# Access Compliance Report

## Public Rights-of-Way

### (Curb Ramps)

Intersection ID: 43985	Main Street: CANYON_CREEK_LN	Cross Street: N_HOSKINS_RD	Location: N
ADA ID: AA87AA90CC7D	Ramp Type: Perp	Initial Pass/Fail: Fail	Overall Compliance: No
			Severity Score: 36.25

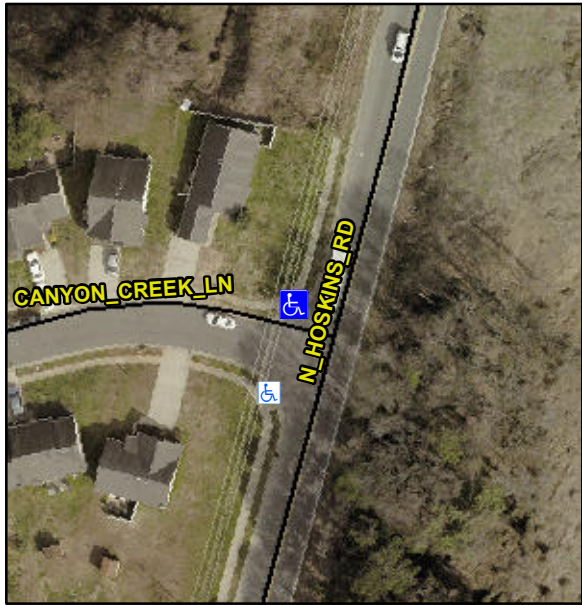
Codes/Mitigation Info/Possible Solution			Field Measurements/Component Compliance					
	Possible Solutions:		Compliance	Description	Data	Compliance	Description	Data
	Remove & Replace Entire Ramp.		N/A	Ramp Length (in)	107.0	Yes	Ramp Slope (%)	7.4
			No	Ramp Width (in)	30.5	No	Ramp XSlope (%)	4.5
			N/A	Flare Type LT	N/A	N/A	Flare Type RT	N/A
			N/A	Flare Slope LT (%)	N/A	N/A	Flare Slope RT (%)	N/A
			N/A	Flare Traversable LT?	N/A	N/A	Flare Traversable RT?	N/A
			N/A	Landing Length (in)	N/A	N/A	DWS Provided?	N/A
			N/A	Landing Width (in)	N/A	N/A	DWS Contrast?	N/A
			N/A	Landing Slope (%)	N/A	N/A	DWS Length (in)	N/A
			N/A	Landing X Slope (%)	N/A	N/A	DWS Full Width?	N/A
Surveyor Notes:			N/A	Landing Curb? (Y/N)	N/A	N/A	DWS Offset (in)	N/A
N/A			N/A	Shared Landing?	N/A			
PROW/ADA:			N/A	Gutter Ponding?	N/A	N/A	Gutter Slope (%)	N/A
R304.5.1, R304.5.3			N/A	Gutter Lip Ht (in)	N/A	N/A	Gutter X Slope (%)	N/A
